STAFF REPORT

BARTHOLOMEW COUNTY PLAN COMMISSION (April 8, 2026 Meeting)

Docket No. / Project Title: SUB-26-18 (NorthPointe Major Subdivision Preliminary Plat)

**TYPICAL
SECTIONS**

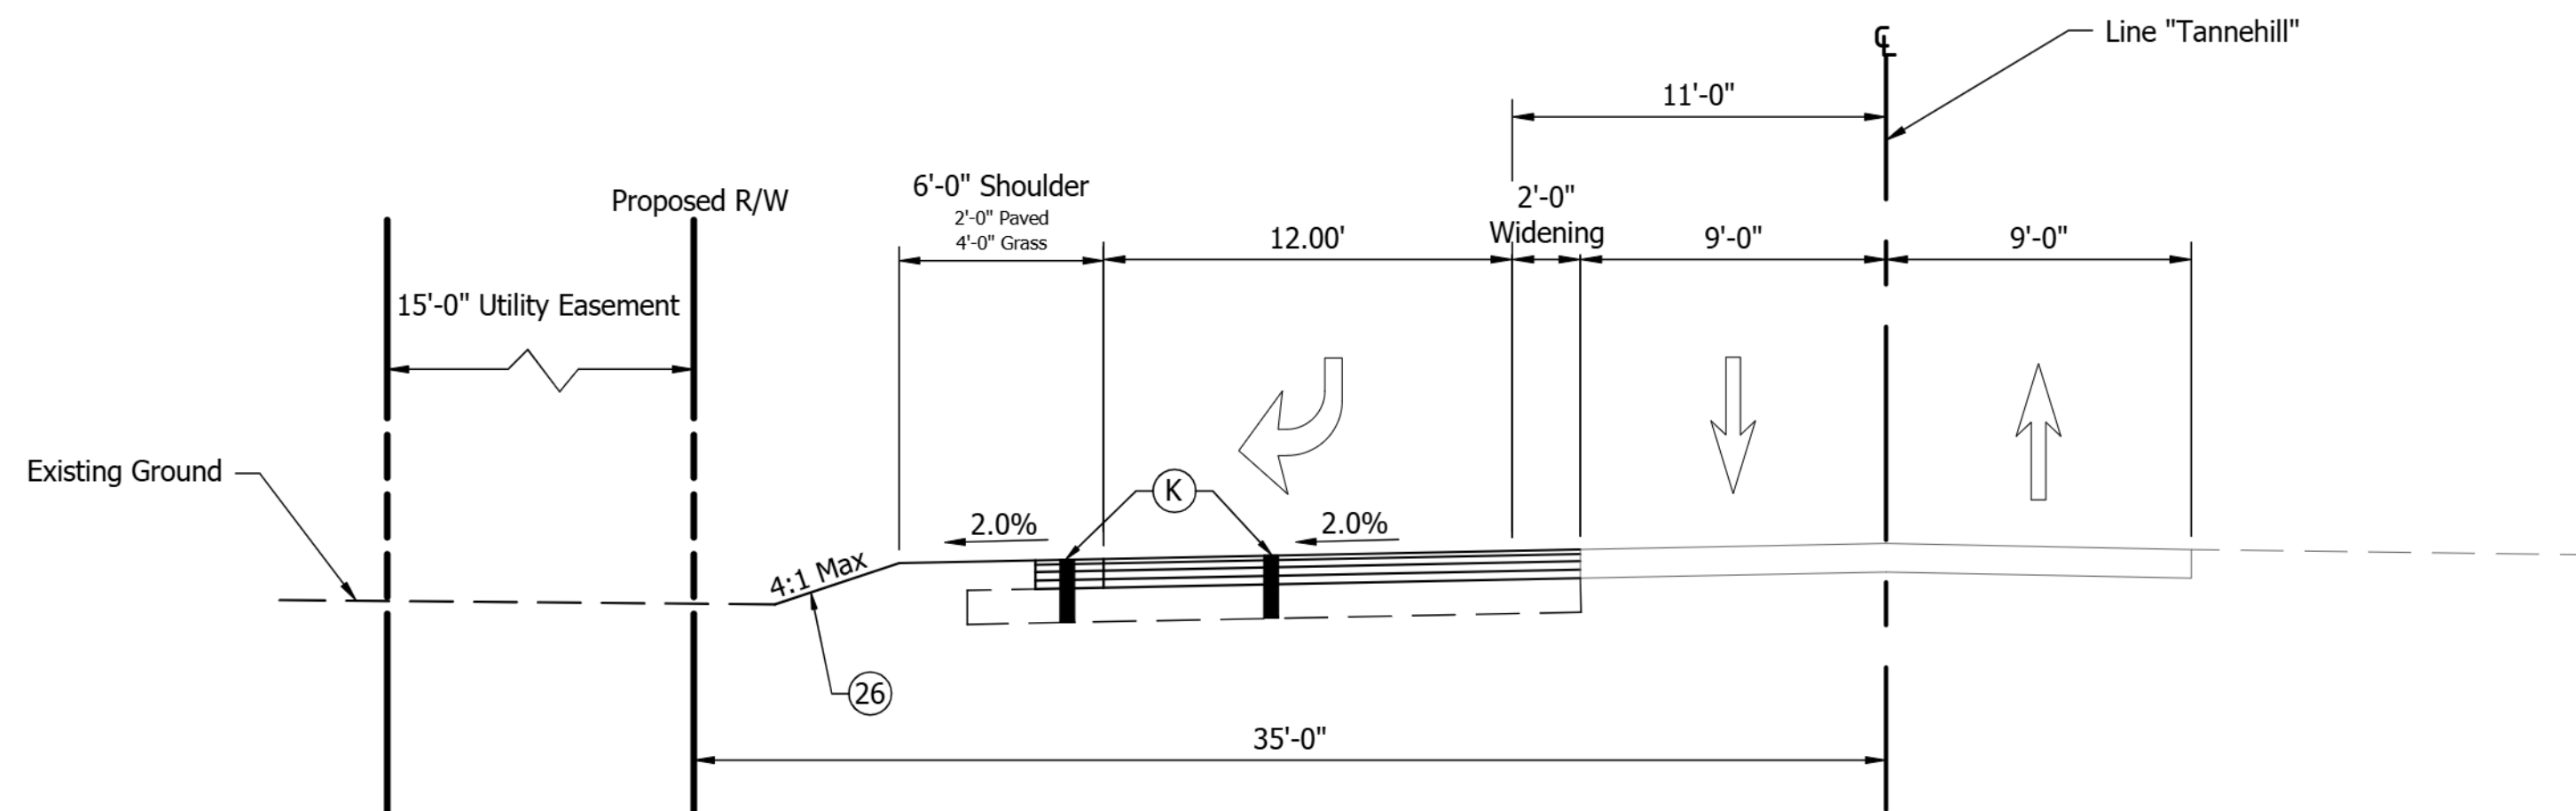
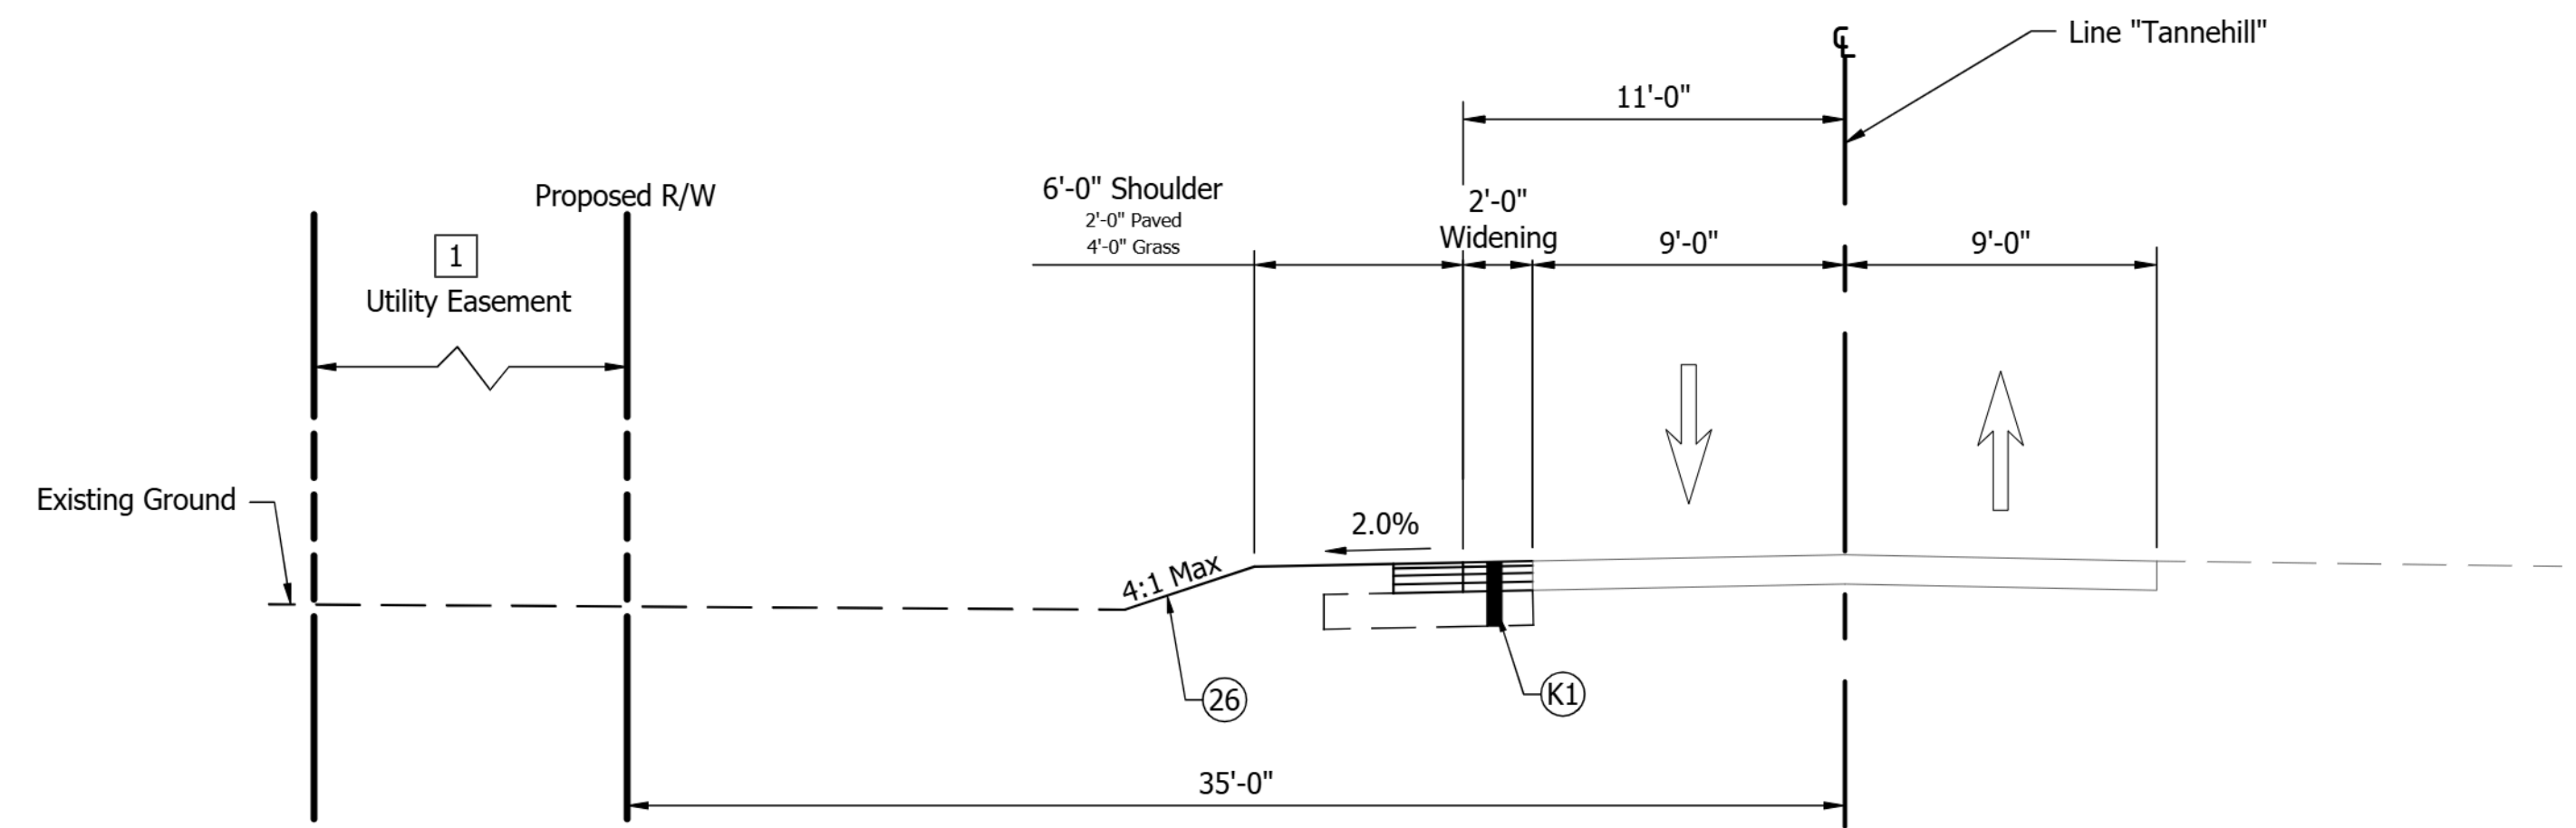
1. Results from Eastern Bartholomew Water Corporation's flow test shall be provided when completed.
2. Sheet 5 (Typical Sections):
 - a. The label of the typical street section shall be revised to read "Subdivision Street Typical Section".
3. Sheet 9 (Construction & Signing Details):
 - a. Curb ramps shall be added at the southern end of the sidewalk along Northpoint Drive, where the stop sign is located. These should be depicted on both sides of the road.
